Proposed Updated Final Safety Analysis Report Tables and Figures
(Mark-Ups; for Information Only)
(164 pages follow)

FINAL PLANT LAYOUT, PLAN C ABOVE
ELEVS. 620'-6", 623'-6" AND
624'-6", PLANT COMPLEX
FIGURE 1.2-5
(DWG. E-013-0005-00000)

Figure 2.4-8

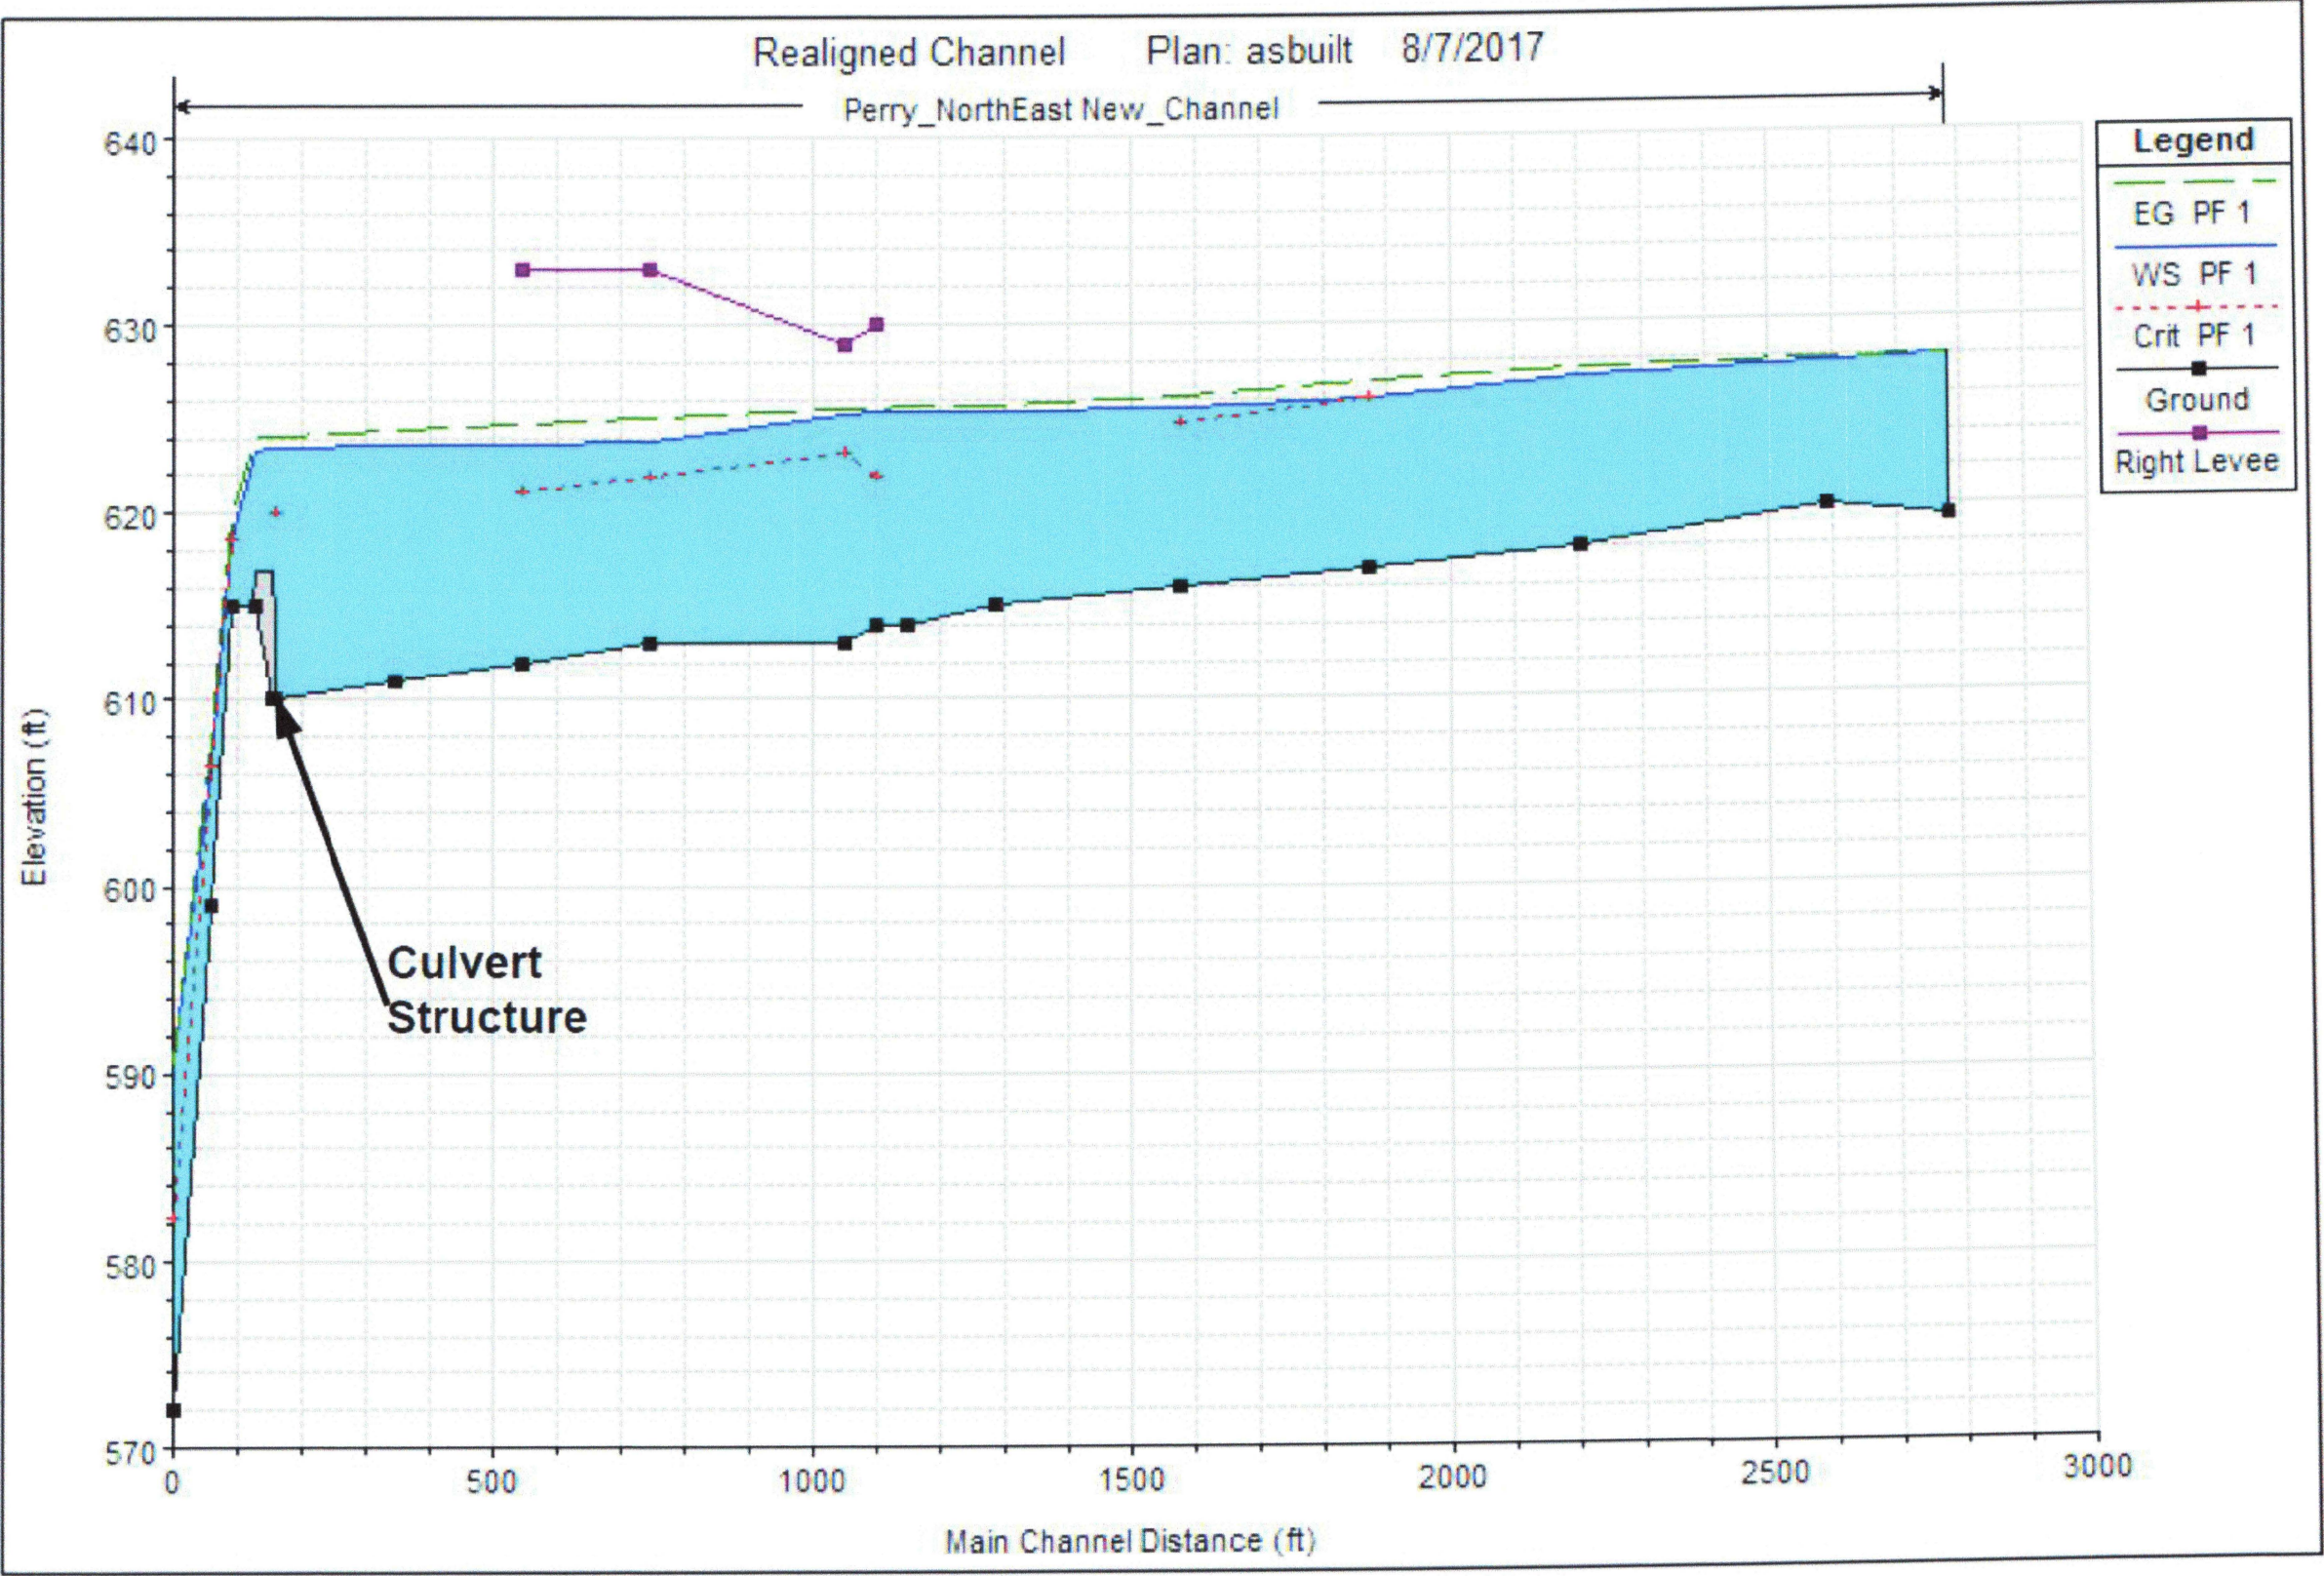
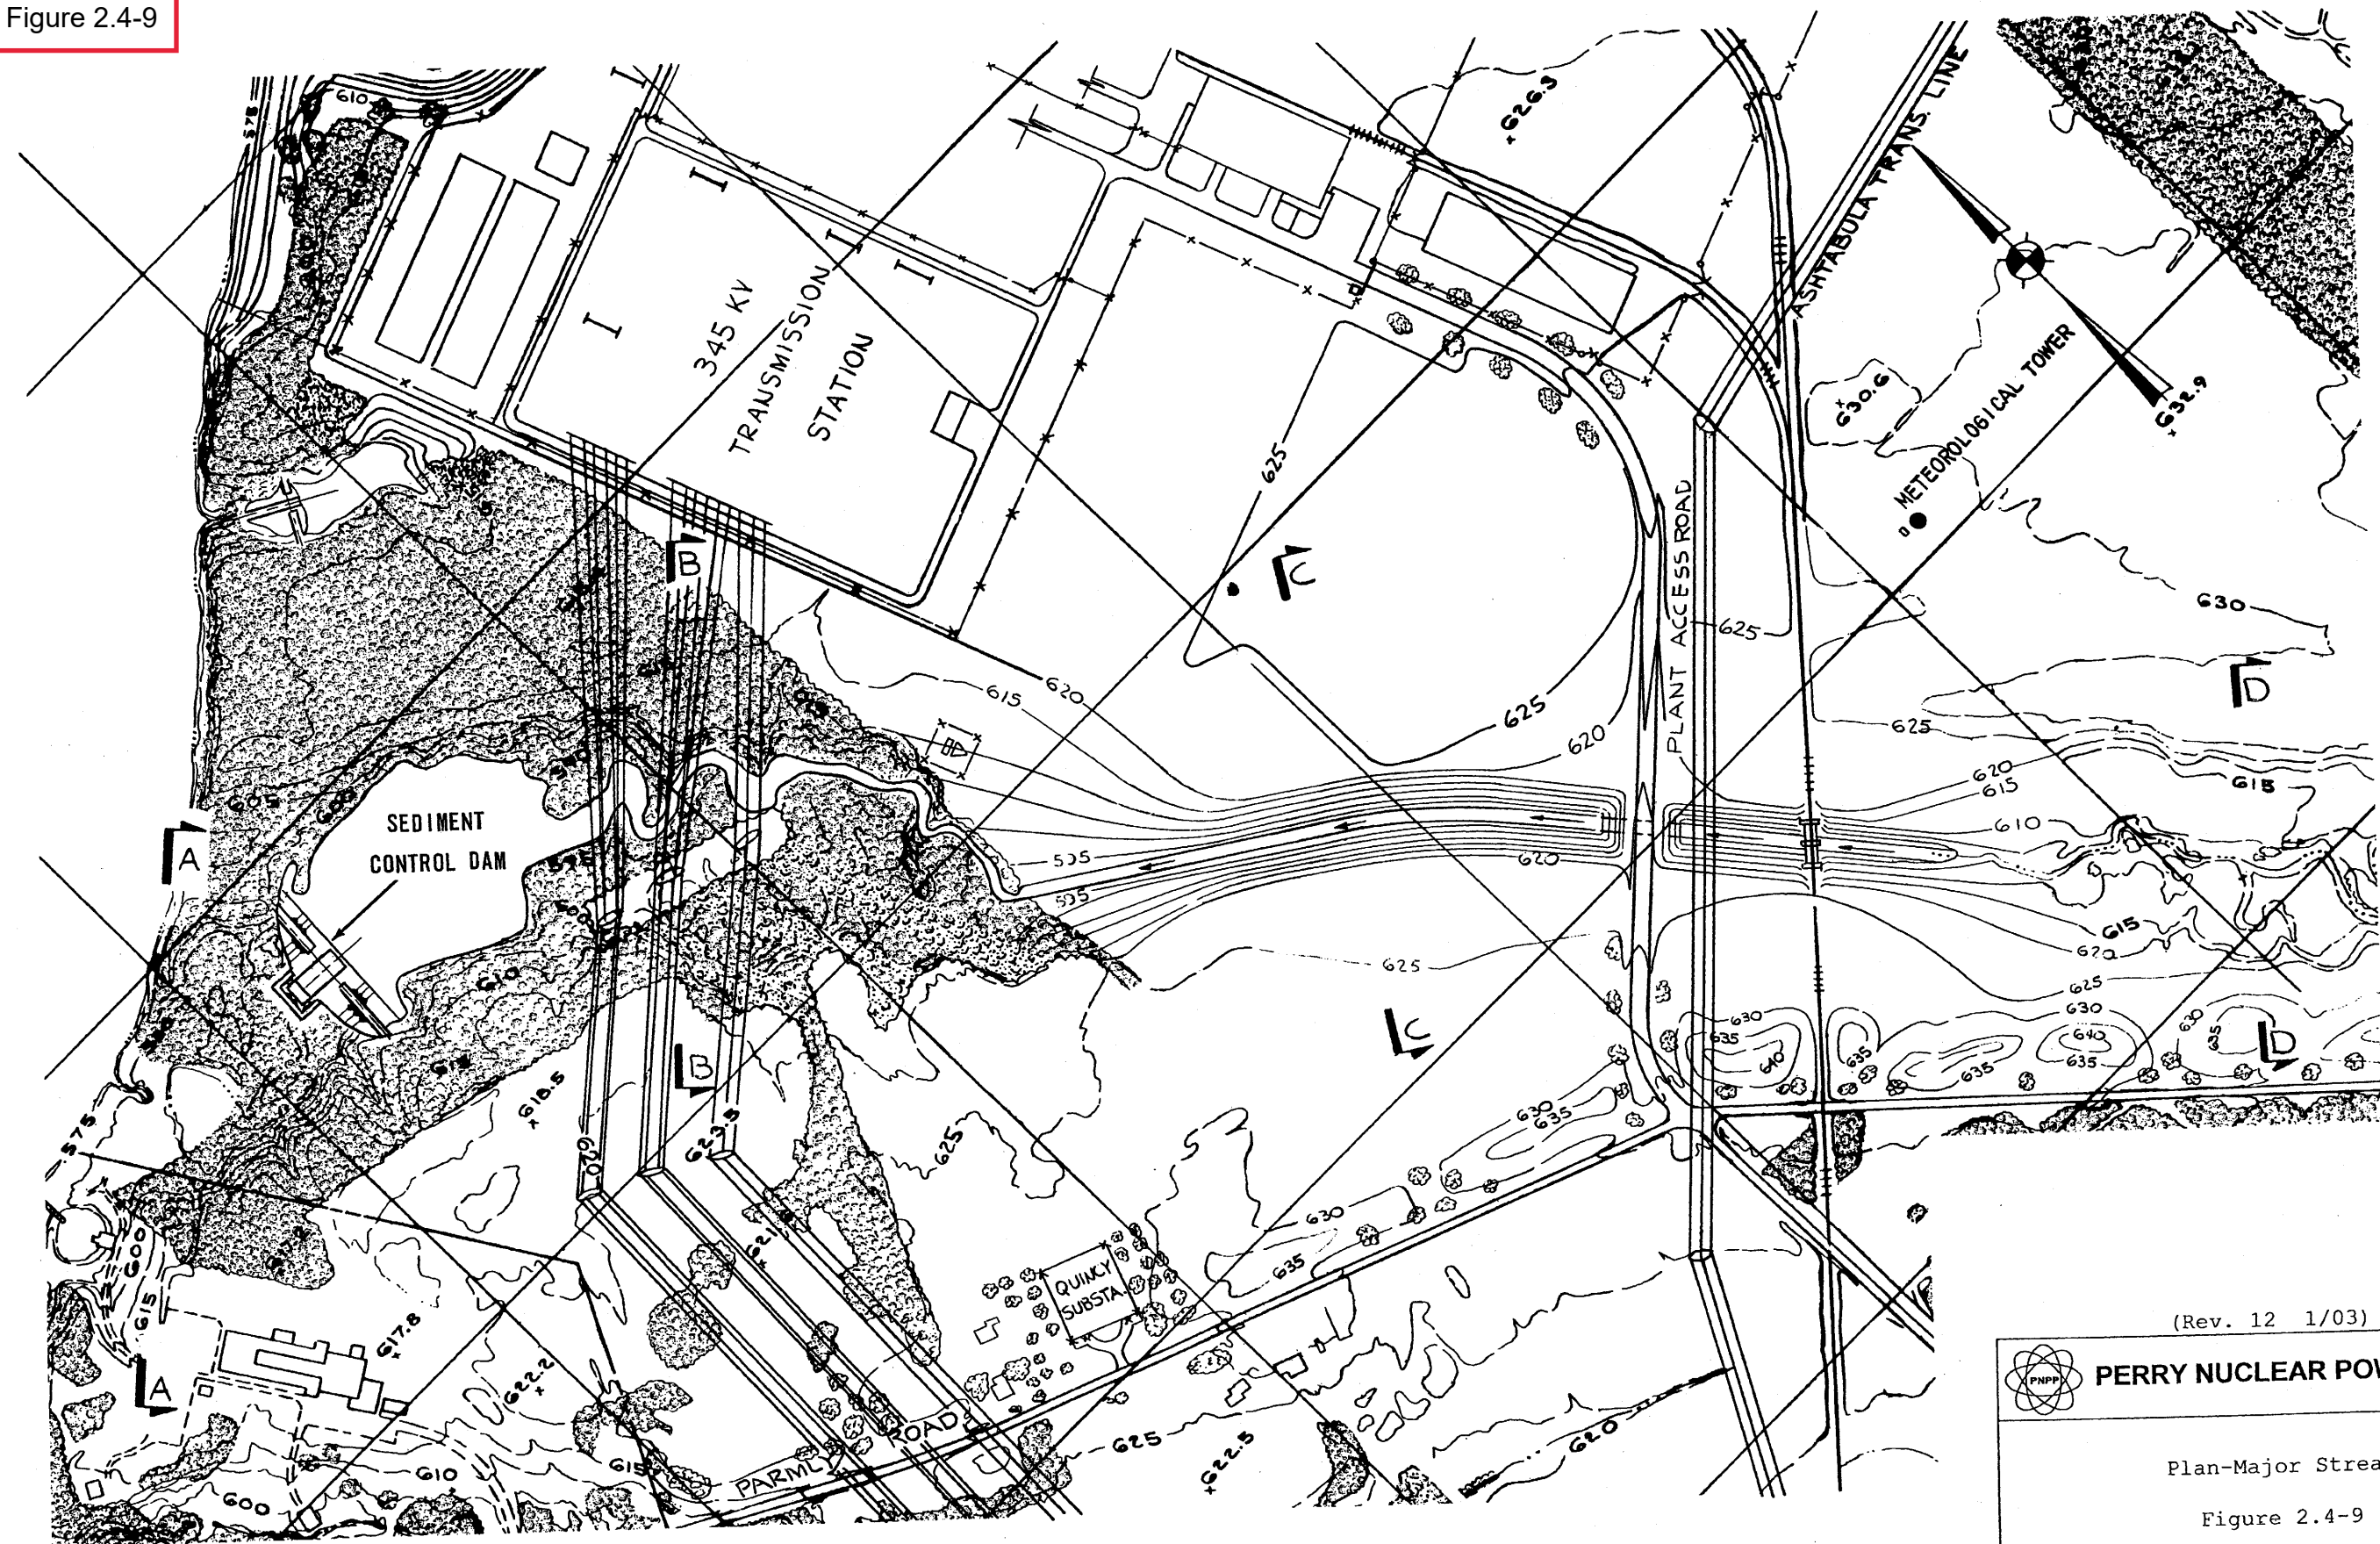
NOTE (NOT FOR
INCORPORATION:
Figure 2.4-8 Revised in
its entirety.

- NOTES:
1. Elevations shown in this Figure are provided in North American Vertical Datum 1988 (NAVD88)
 2. For comparison to plant building elevations, convert NAVD88 to PLD
 3. NAVD88 + 0.93 ft = Perry Local Datum (PLD)
 4. Source: PNPP Calculation 50:73.000
